Access Compliance Report

Public Rights-of-Way

Intersection ID: 21458	Main Street: PROVIDENCE_RD	Cross Street: SARDIS_LN	Location: NE
ADA ID: C072933ABDEF	Ramp Type: PerpDiag	Initial Pass/Fail: Fail	Overall Compliance: No
		Severity Score: 22.5

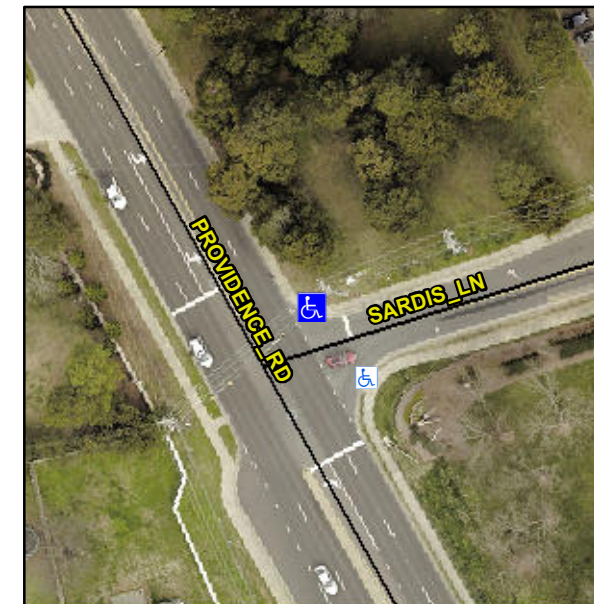
Not Found, R304.5.1, R304.2.2, R304.5.3

Compliance	Description	Data	Compliance	Description	Data
N/A	Ramp Length (in)	45.0	No	Ramp Slope (%)	9.2
No	Ramp Width (in)	43.0	No	Ramp XSlope (%)	3.1
N/A	Flare Type LT	N/A	N/A	Flare Type RT	N/A
N/A	Flare Slope LT (%)	N/A	N/A	Flare Slope RT (%)	N/A
N/A	Flare Traversable LT?	N/A	N/A	Flare Traversable RT?	N/A
N/A	Landing Length (in)	N/A	N/A	DWS Provided?	N/A
N/A	Landing Width (in)	N/A	N/A	DWS Contrast?	N/A
N/A	Landing Slope (%)	N/A	N/A	DWS Length (in)	N/A
N/A	Landing X Slope (%)	N/A	N/A	DWS Full Width?	N/A
N/A	Landing Curb? (Y/N)	N/A	N/A	DWS Offset (in)	N/A
N/A	Shared Landing?	N/A			
N/A	Gutter Ponding?	N/A	N/A	Gutter Slope (%)	N/A
N/A	Gutter Lip Ht (in)	N/A	N/A	Gutter X Slope (%)	N/A
N/A	Painted X Walk1?	No	N/A	Painted X Walk2?	No
	X Walk 1 Direction	To SW		X Walk 2 Direction	To SE
N/A	X Walk 1 Width (in)	N/A	N/A	X Walk 2 Width (in)	N/A
	X Walk 1 Slope (%)	0.9		X Walk 2 Slope (%)	0.4
	X Walk 1 X Slope (%)	0.5		X Walk 2 X Slope (%)	0.1

Remove & Replace Curb Ramp With Two New Directional Ramps or Equivalent.
